**Hudson River Valley Greenway Link**

**Task #5  
Workshop #2  
Final Report**

November 3, 2010

# FRIENDS OF THE HUDSON RIVER GREENWAY IN THE BRONX - GREENWAY LINK

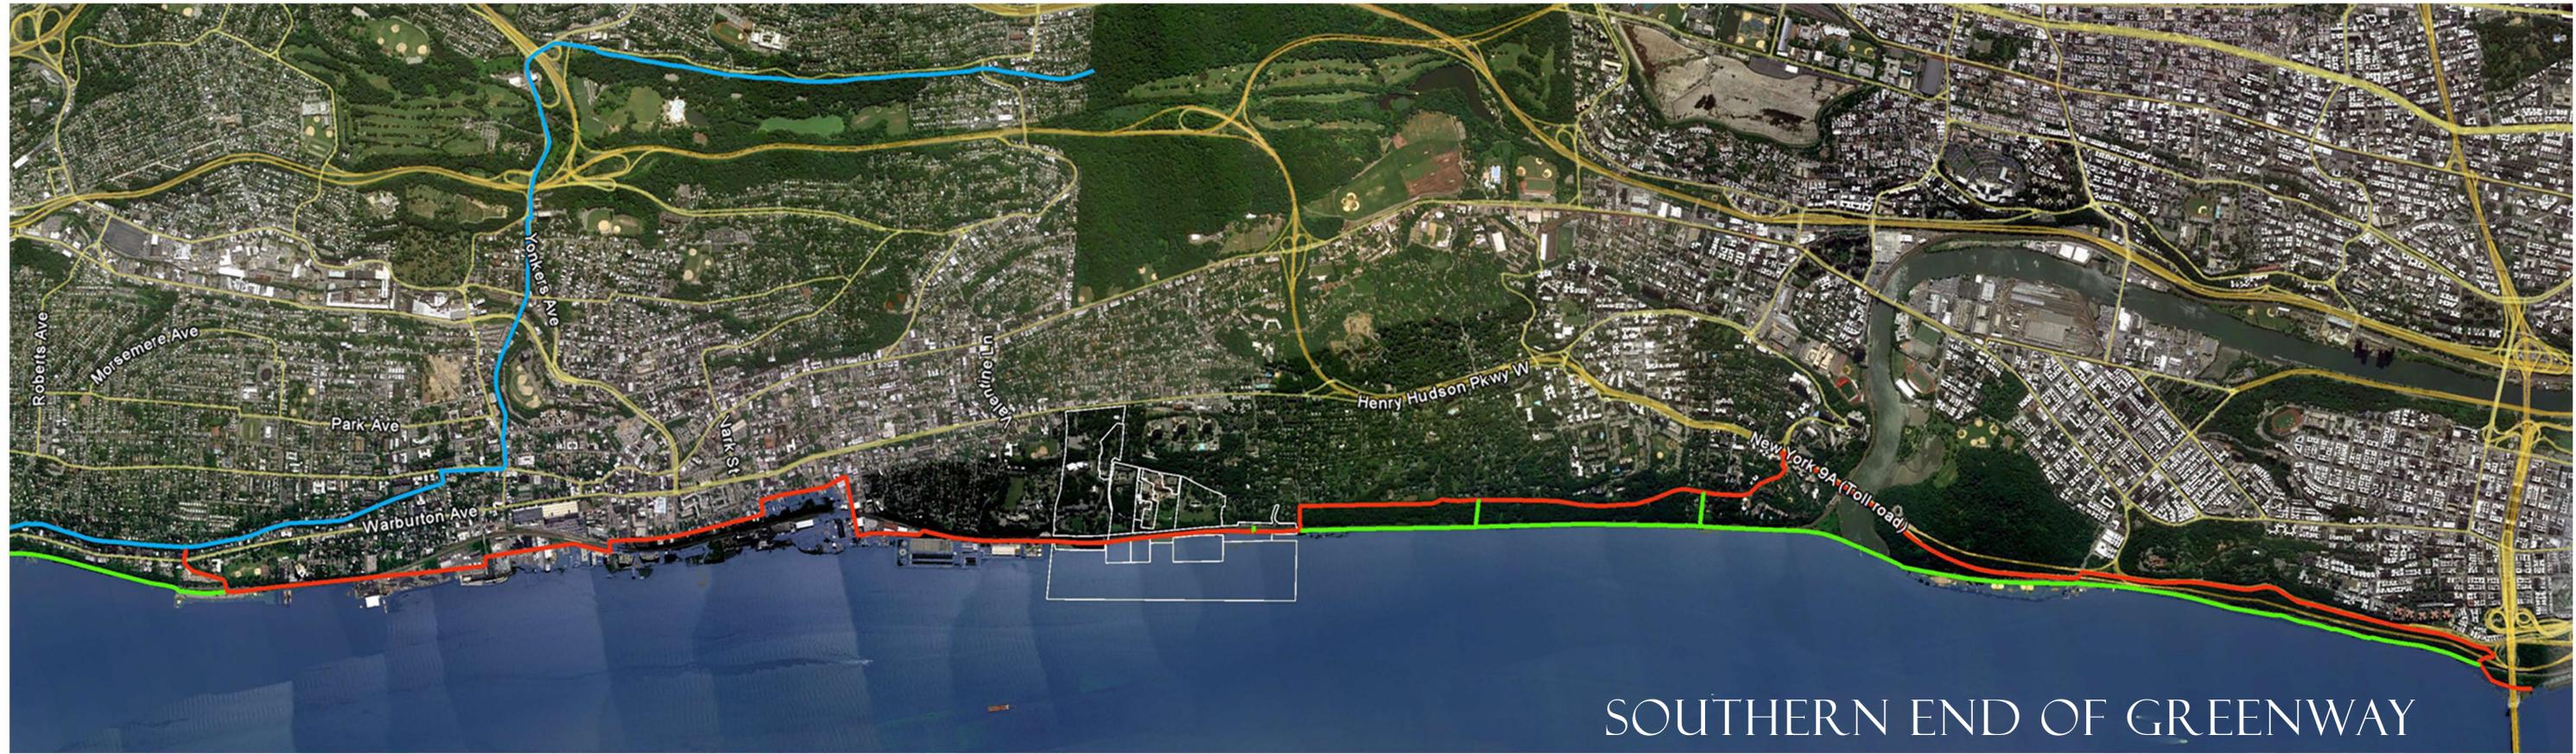
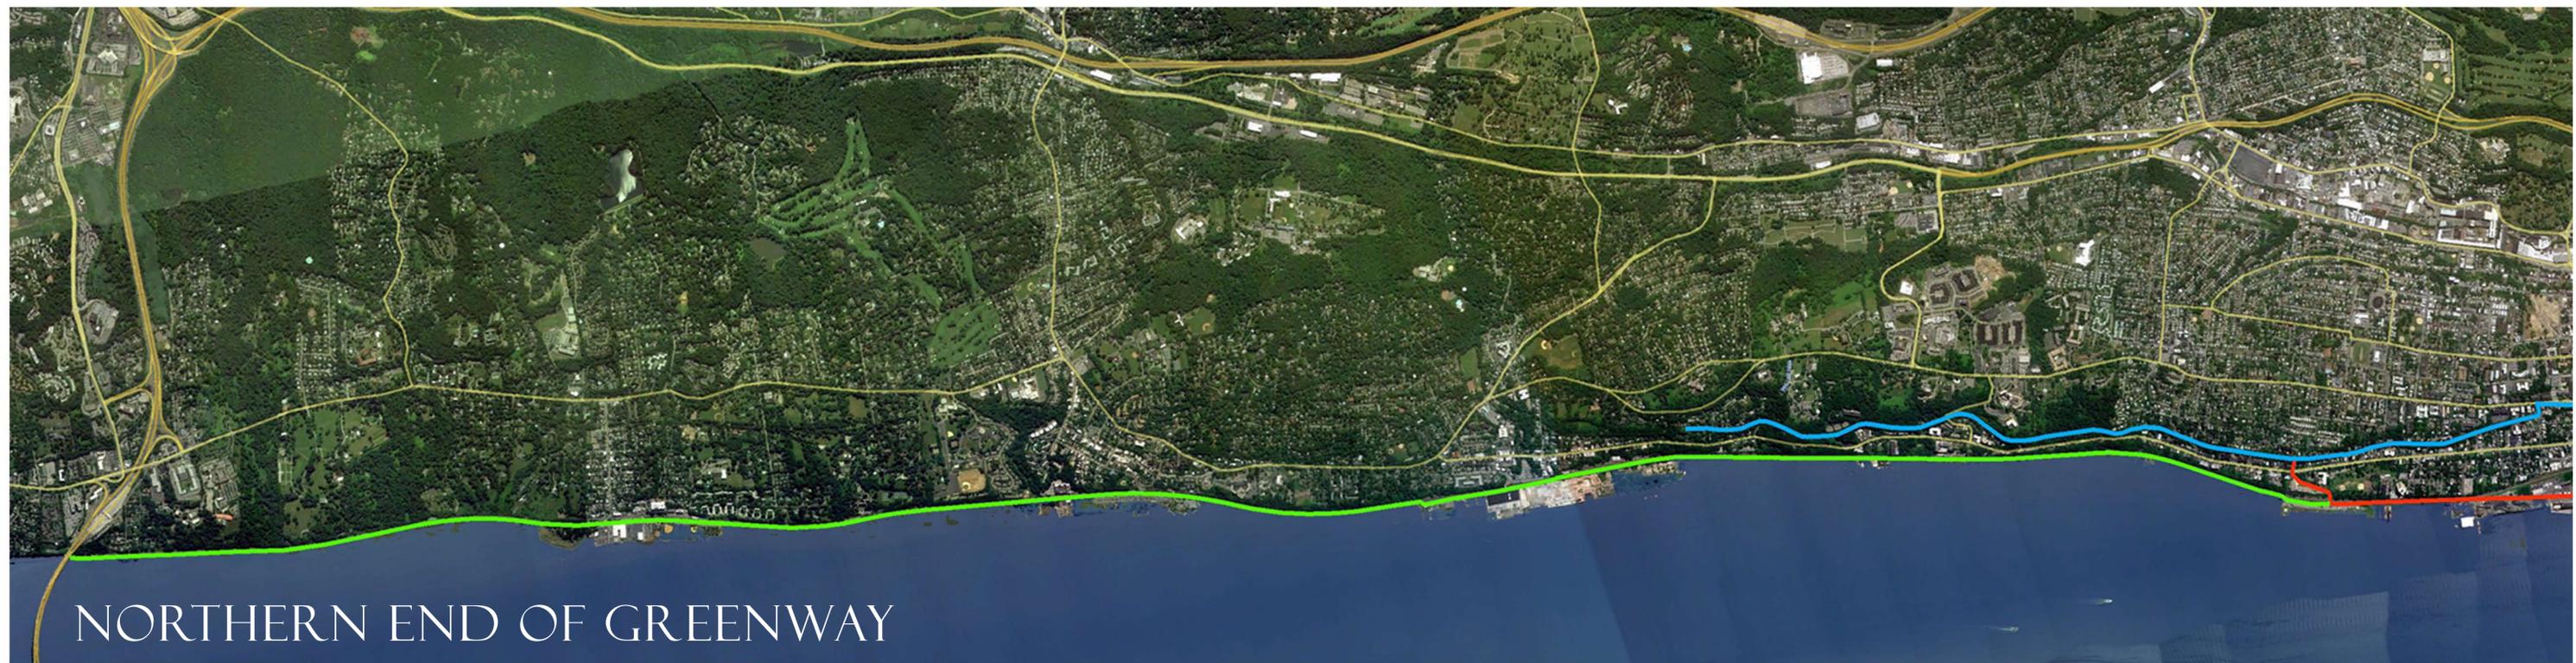
- Improvement in the connection between existing Manhattan Greenway and the HHB. Both proposed alternatives do nothing to improve the connection which requires bikers and walkers to climb over the railroad bridge and up a very steep hill to the bridge. The hill is so steep that it is impossible to get up it without dismounting from your bike. The detailed study should evaluate two alternative connections:

- Descend directly to Dyckman Street from the existing Manhattan Greenway on a new ramp immediate east of the old powerhouse (that is under renovation and build a new greenway connection from Dyckman to the HHB that hugs the west side of southbound lane – and has a gradual grade that is manageable by bikers.

- Cantilever over Dyckman on the western edge of the northbound highway lane, cross over to the west side of the southbound lane and build a new ramp that hugs the southbound lane to HHB and connects to the HHB.

- Creating a standard size walking and biking route over the HHB by eliminating the most western lane of car traffic and dedicating that space to a bike and walking lane.
